UNITED STATES PATENT AND TRADEMARK OFFICE

| APPLICATION NO. | FILING DATE | FIRST NAMED INVENTOR | ATTORNEY DOCKET NO. | CONFIRMATION NO. |
|-----------------|-------------|----------------------|---------------------|------------------|
| 09/652,998 | 08/31/2000 | D. Mark Durcan | 98-1068.06 | 4016 |

Office Action Summary

DETAILED ACTION

FIG. 12

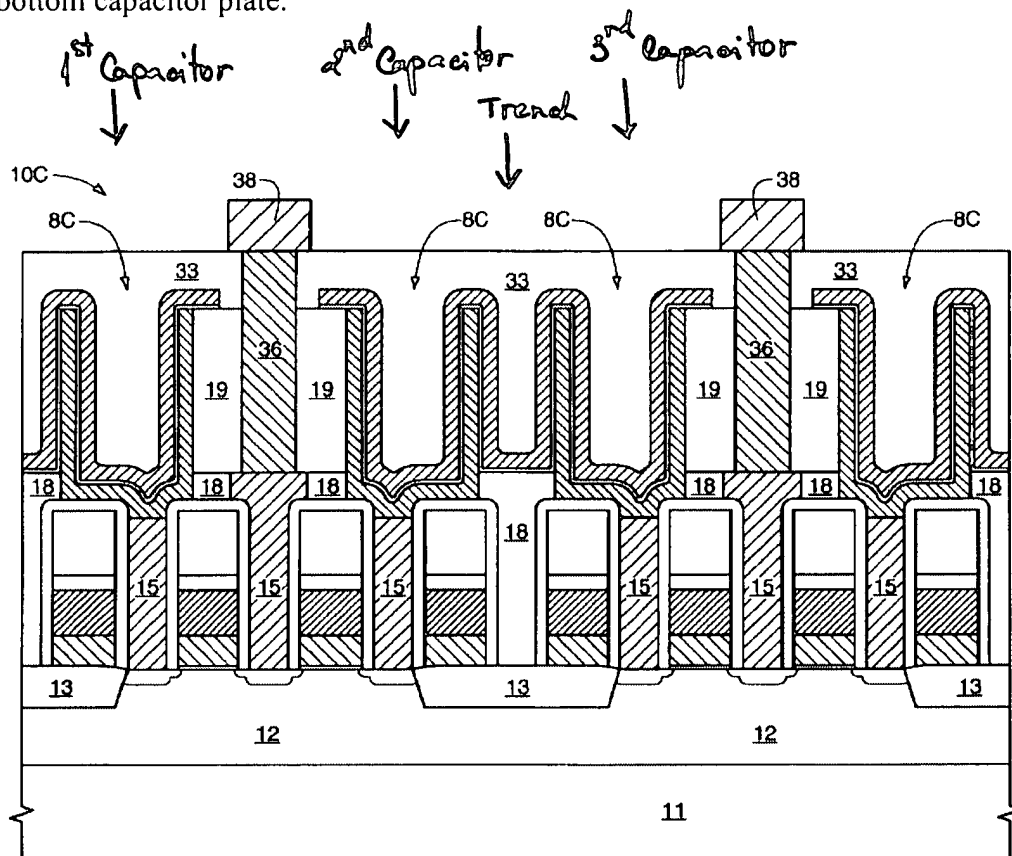
As shown in Fig. 12, the top capacitor plate 24c lining the trench between the second and third bottom capacitor plates (middle of the drawing). Clearly, the top capacitor plate 24C is vertically descent between the second and third bottom capacitor plates. (See below).

As best understood by the examiner, the top capacitor plate is vertically descent between each of the second and third bottom capacitor plates but does not descent between the first and second bottom capacitor plate.

Note that, the trench is locate between the second the third bottom capacitor plates (lines 8-9). (See Fig. 12 above).

How can top capacitor plate lining the side (vertically descent) of the trench be characterized as does not vertically descent ?

FIG. 10

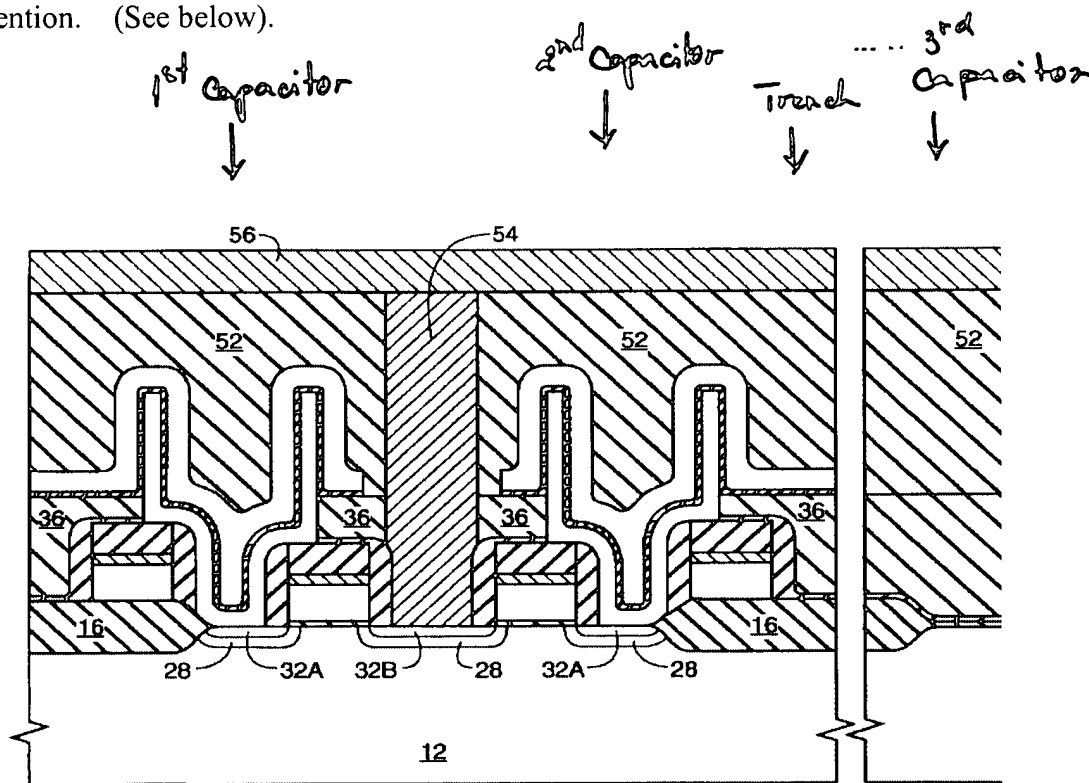
a dielectric (46) between the top capacitor plate (50) and the first, second, and third bottom capacitor plates (44). (See Fig. 10).

With respect to the third bottom capacitor plate (44), although Becker does not show a third bottom capacitor plate (44) in the drawing, however, one having ordinary skill in the art should recognize that the third bottom capacitor plate is actually the first bottom capacitor plate of the adjacent cell, on the outside (left and right) of the first and second bottom capacitor plates (44) since the capacitors of Becker are formed in an array, as shown in Fig. 1 (prior art) of the present invention. (See below).

a bit line contact insulation region (36/52) surrounding the bit line contact (54) and filling the region between the bit line contact (54) and the bottom electrodes (44). (See Fig. 10).

a bit line contact insulation region (36/52) surrounding the bit line contact (54) and filling a region between the bit line contact (54) and the first and second bottom electrodes (44). (See Fig. 10).
